Well information: **30-039-05420 JICARILLA APACHE B #009**

Plug and Abandonment Procedure
DJR Operating, LLC
Jicarilla Apache B 9
API # 30-039-05420
NE/NE, Unit A, Sec. 20, T24N, R05W
Rio Arriba County, NM

BLM FLUID MINERALS Geologic Report

Re: Permanent Abandonment
Well: Jicarilla Apache B #9
(API# 30-039-05420)

Proposed Wellbore P&A Diagram

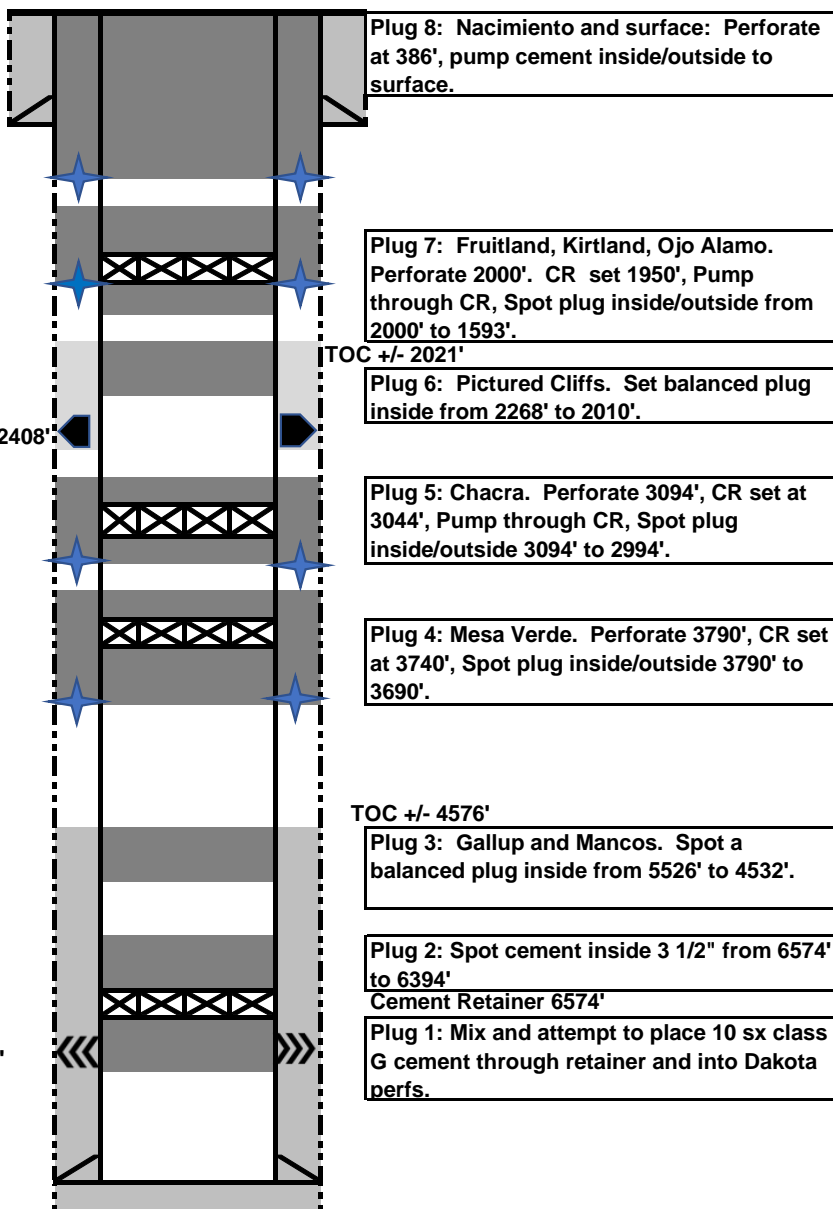
- Notify NMOCD 24 Hours prior to commencing activities
- In addition to the BLM approved plugs, add the following:
Mancos plug inside outside above TOC.
Pictured Cliffs plug inside outside.

- BLM geologist's picks for the tops of the Kirtland, Fruitland and Dakota formations vary from operator picks.
- Log analysis of reference well #2 indicates the San Jose, Nacimiento and Ojo Alamo sands investigated likely contain fresh water to usable water ($\leq 10,000$ ppm TDS). The proposed P&A plan has adequate plugs to ensure freshwater and usable water sands are protected in this well bore.
- A previous P&A plan was approved by the Farmington BLM office on May 15, 2014. The proposed P&A plan submitted July 21, 2020 adequately incorporates changes made by BLM to the 2014 plan, and covers all formation tops adequately.
- Dakota perforations @ 6586'-6657'.
